## APPROVED TACHOGRAPH CENTRE SPECIAL NOTICE

### SN 2 - 2009

## Appendix M

### **Amendment to Tachograph Calibration Bay Dimensions** **This Appendix shall be applicable from the 1<sup>st</sup> May 2009**

Drawing 3: Minimum dimensions required for a flat bay incorporating a Brake Roller Tester (RBT) with tachograph conversion – with no pit

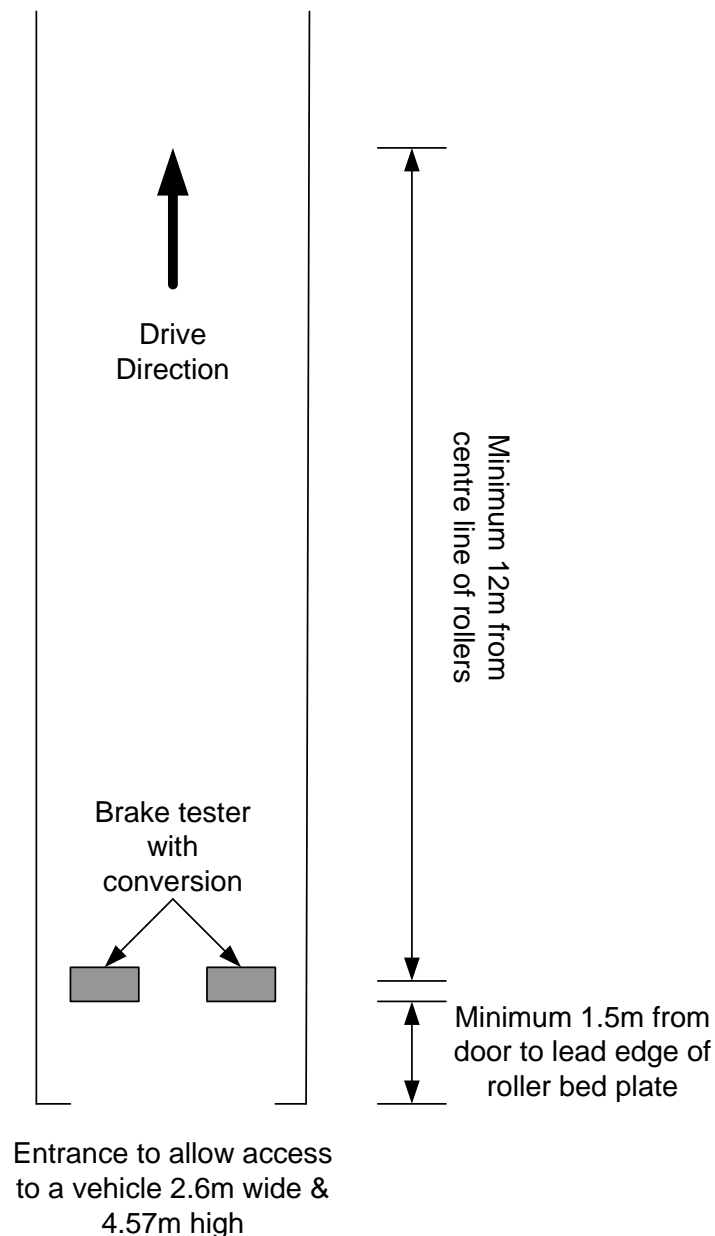
Drawing 3: Calibration Bay Only: Minimum dimensions required for a flat bay incorporating a Roller Brake Tester (RBT) with tachograph conversion – with no pit, the bay length can be of any length provided there is a minimum measurement from the centre line of the RBT forward to the bay doors to provide undercover protection to the technician and cab of the vehicle of 12m. A pit can be incorporated into this bay layout of any length provided it meets the minimum dimensions and safety requirements detailed in drawing 3.

The brake rollers can be installed a minimum of 1.5m inside the entrance; this distance will prevent the need for a person entering the bay and walking directly onto the roller bed and will help prevent water ingress into the rollers in inclement weather.

With this layout the overhang of the vehicle will be permitted to remain outside of the bay, this has been considered acceptable due to the low risk of debris being thrown from the tyres at the lower operating speed and the absence of noise pollution again due to the low operating speed of the rollers.

This layout is considered acceptable for any bay length provided there is the minimum 12m clearance from the centre line of the rollers forward.
